BAR Meeting
June 17, 2009

ISSUE: Addition and Alterations
APPLICANT: Dominion Design Associates, LLC by Dennis Powell
LOCATION: 513 Duke Street
ZONE: RM/Residential

BAR CASE #2009-0084, 0085 6/17/2009

The applicant is requesting approval of a Certificate of Appropriateness for a third story rear addition and alterations at 513 Duke Street.

Figure 11. Proposed north elevation.

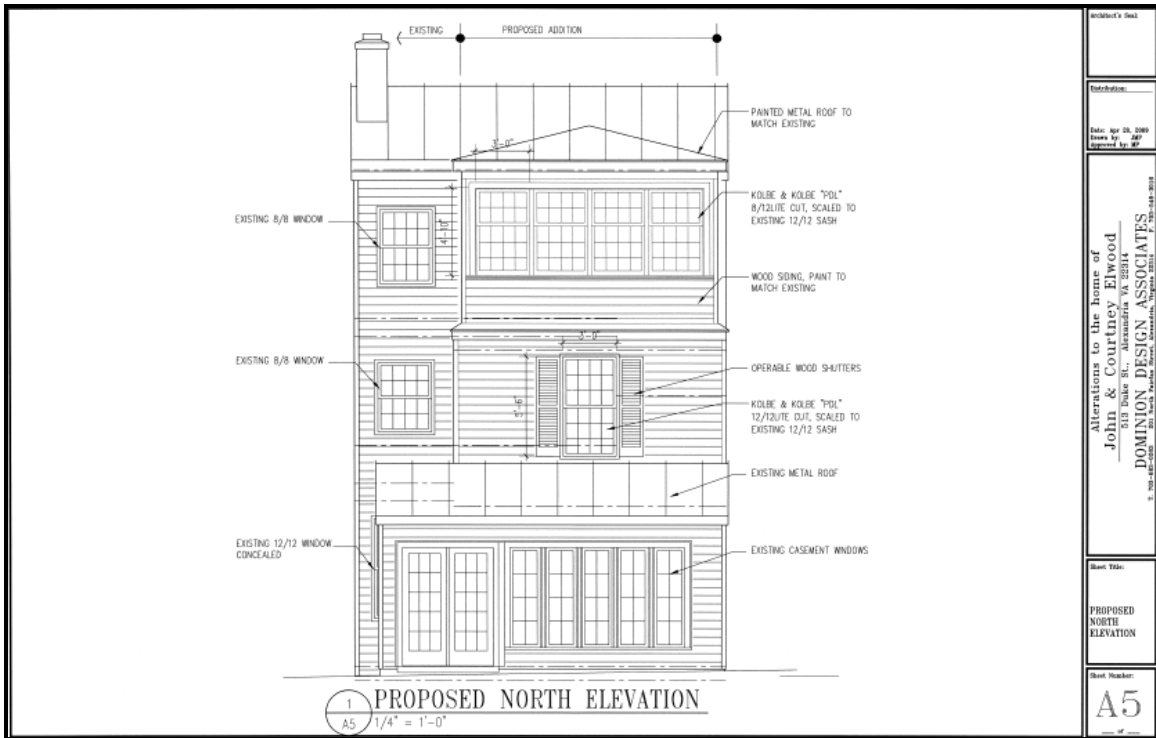
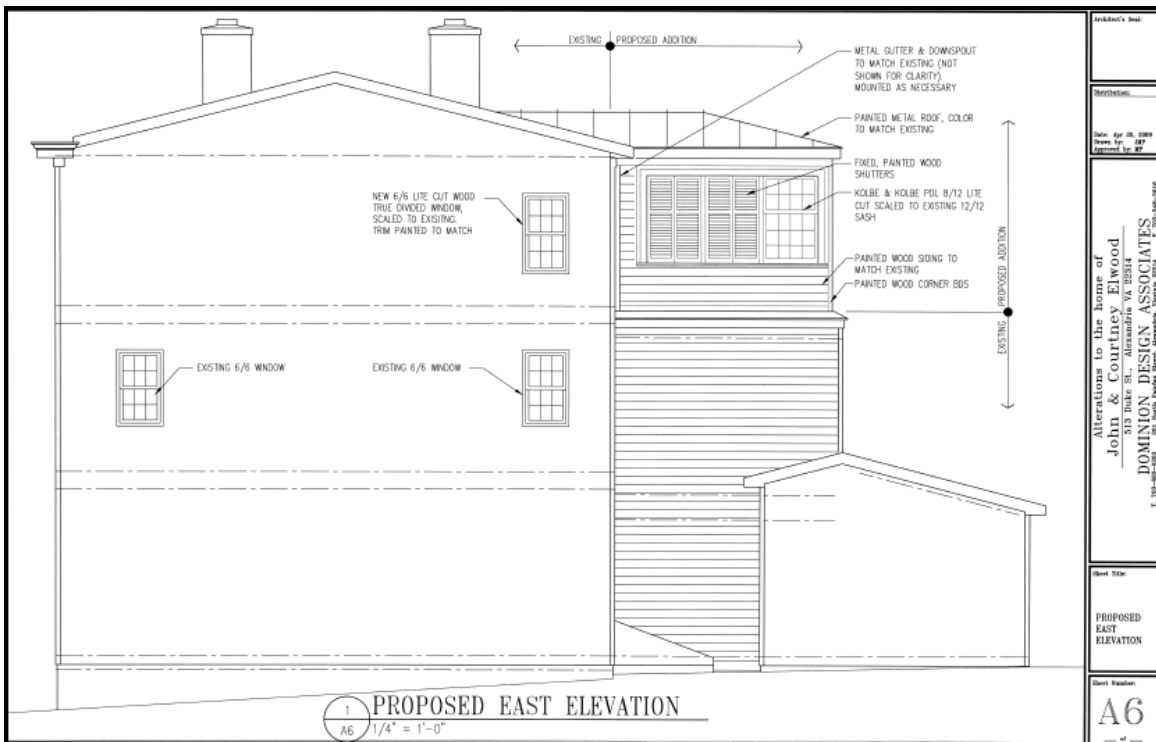
While single-glazed, true-divided-light wood windows are preferable, the *Design Guidelines* and the Board generally allow for double-insulated, simulated-divided-light wood windows and doors on new construction or in areas with limited visibility. Staff supports their use in this particular case because the windows will be visible only from approximately 230 feet away on South St. Asaph Street, too far, in Staff’s opinion, to determine that the windows are double-glazed. However, Staff does not support the use of Kolbe & Kolbe “performance divided lites” because they have aluminum muntins on the exterior, which Staff believes may weather inconsistently over time. Staff recommends that the windows installed by the applicant have wood, and not aluminum, muntins.

Staff recommends approval of the application with the condition that if the windows proposed along the north elevation are not permitted by Code Administration that the applicant revise the design to provide recessed brick panels to simulate closed window openings in place of the proposed windows.

1. That the muntins on the double-glazed, simulated divided light wood windows on the addition and the replacement window on the second floor rear elevation be constructed of wood and not aluminum;
